# Hornsea Project Four

## Applicant's comments on Harbour Energy's Deadline 6 submissions

**Document Reference: G7.10**

Figure 1: Impact of Johnston Protective Provisions proposed by Harbour Energy at Deadline 6

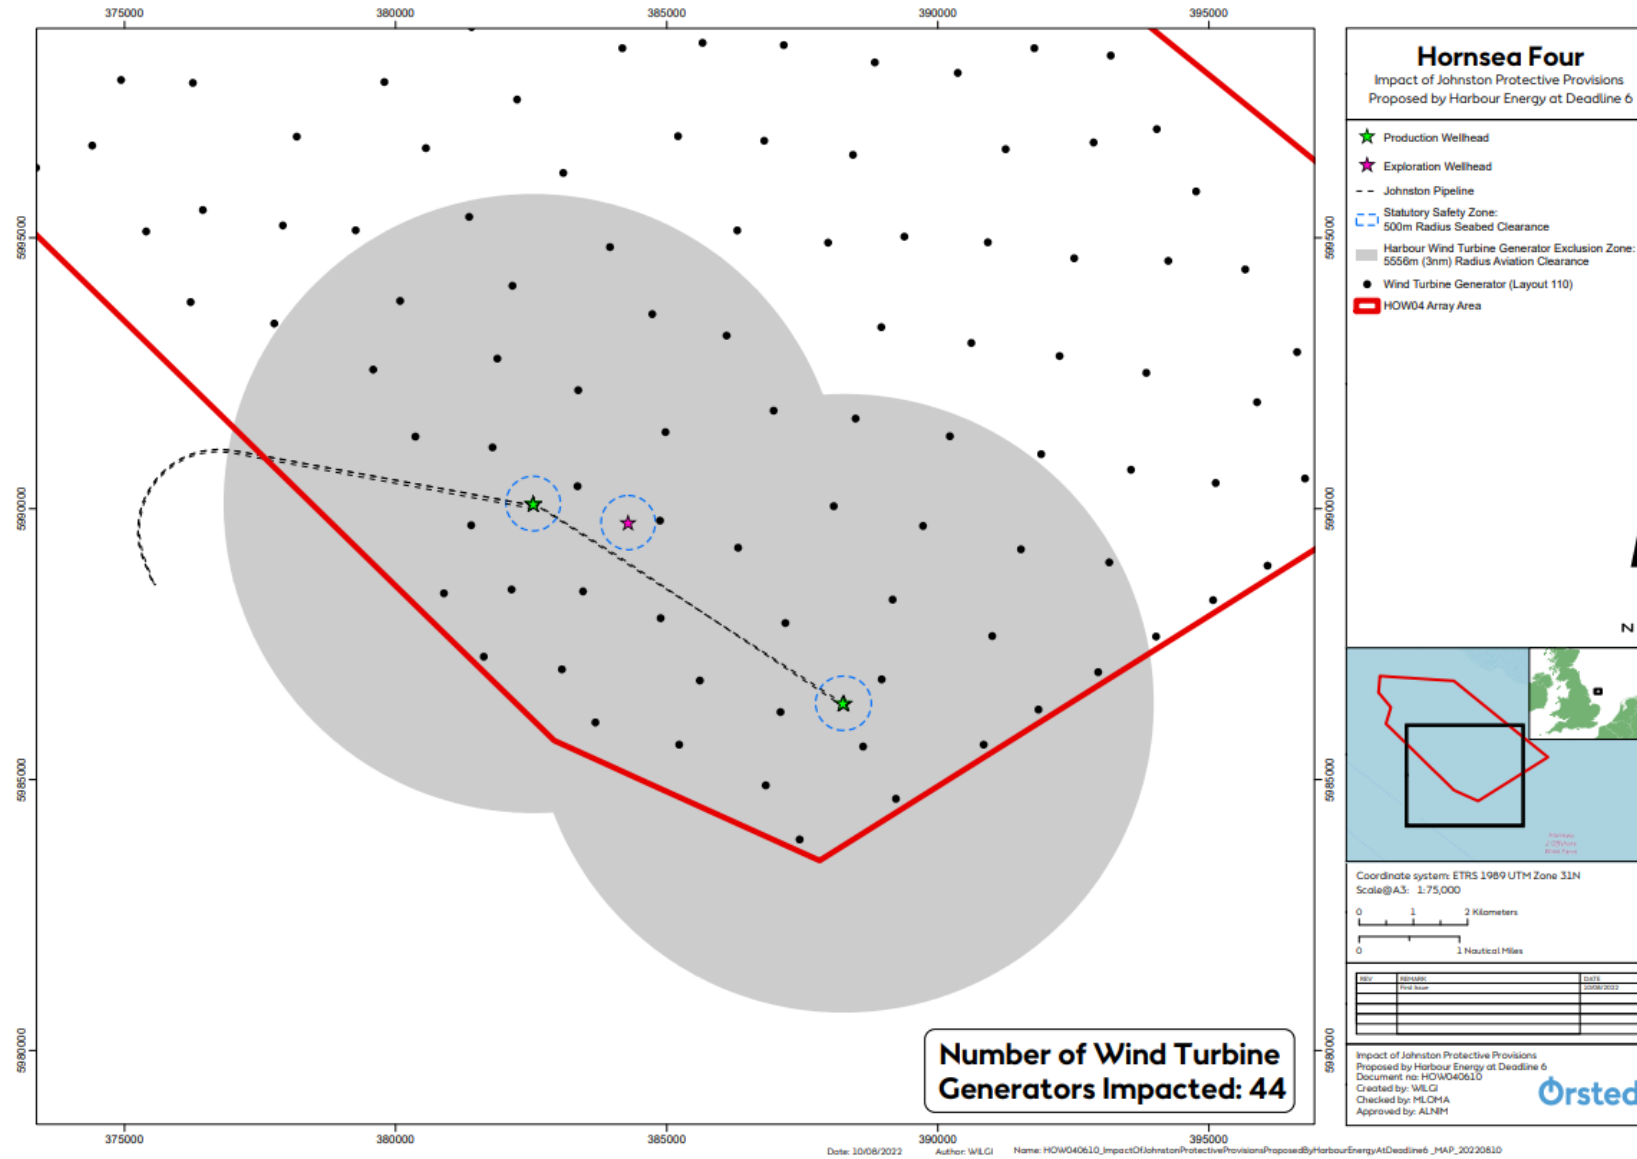
- 3.1.1.6 It would be disproportionate to sterilise a greater area than absolutely necessary to decommission. The Applicant has provided a plan at [Figure 1](#) demonstrating, on an indicative basis only, the impact upon the potential turbine locations of a 3nm radius exclusion zone around the production wellheads. A 3nm radius exclusion zone would result in a loss of 44 turbine positions which would be wholly unacceptable to the Applicant and would have a major adverse impact upon the viability of the windfarm due to the significant reduction in capacity. The Applicant would stress, however, that any distance greater than the proposed 900m WTG exclusion zone and 800m aviation corridor offered would have an adverse impact upon the windfarm which cannot be justified for the sole purpose of reducing the logistical inconvenience posed by the location of the turbines.
